SUPPLEMENTAL RESPONSE TO REQUEST FOR ADDITIONAL INFORMATION

APR1400 Design Certification

Docket No. 52-046

RAI No.: 481-8546
SRP Section: 16 - Technical Specifications
Application Section: 16.3.4, 16.3.5, 16.3.6, 16.3.7, 16.3.9
Date of RAI Issue: 05/12/2016

3.4.2 RCS Minimum Temperature for Criticality

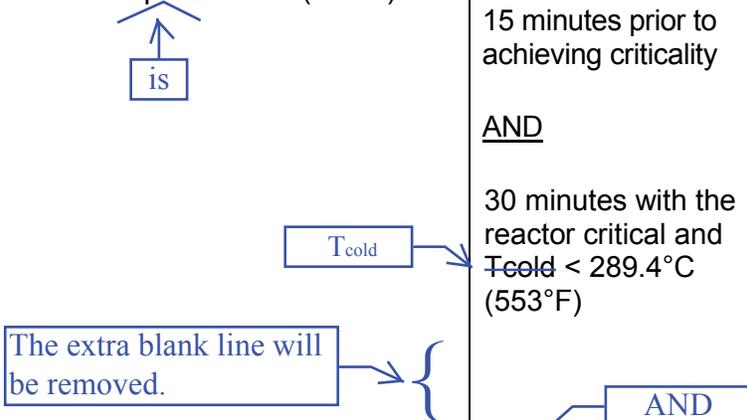
1. Generic TS SR 3.4.2.1 Frequency is missing the 12 hour Frequency, which is included in the Deviation Report. Also, the 12 hour Frequency should be second, not third, since only the last Frequency may have a Note, per TSTF-GG-05-01 Paragraph 4.1.7.e. But that conflicts with the convention to have Frequencies listed from smallest interval to largest interval. The applicant is requested to remove the Note and state the 30 minute Frequency as "30 minutes with the reactor critical and $T_{\text{cold}} < 289.4 \text{ }^{\circ}\text{C}$ (553 $^{\circ}\text{F}$)".
2. Generic TS 3.4.4, "RCS Loops - MODES 1 and 2," LCO 3.4.4 states, "Two RCS loops shall be OPERABLE and in operation with two reactor coolant pumps operating in each loop." The Deviation Report states it as "Two RCS loops shall be OPERABLE and two reactor coolant pumps

SR 3.4.2.1 will be revised by adding “is” and changing “OR” to “AND” as shown in Attachment 2 to incorporate NRC staff’s request. The T_{cold} in the second FREQUENCY will be revised to T_{cold} and one of the extra blank lines between the second and third FREQUENCY will be removed.

SURVEILLANCE	FREQUENCY
SR 3.4.2.1 Verify RCS T_{cold} in each loop $\geq 286.7^{\circ}\text{C}$ (548°F). 	Once within 15 minutes prior to achieving criticality <u>AND</u> 30 minutes with the reactor critical and $T_{cold} < 289.4^{\circ}\text{C}$ (553°F) OR <u>AND</u> 12 hours
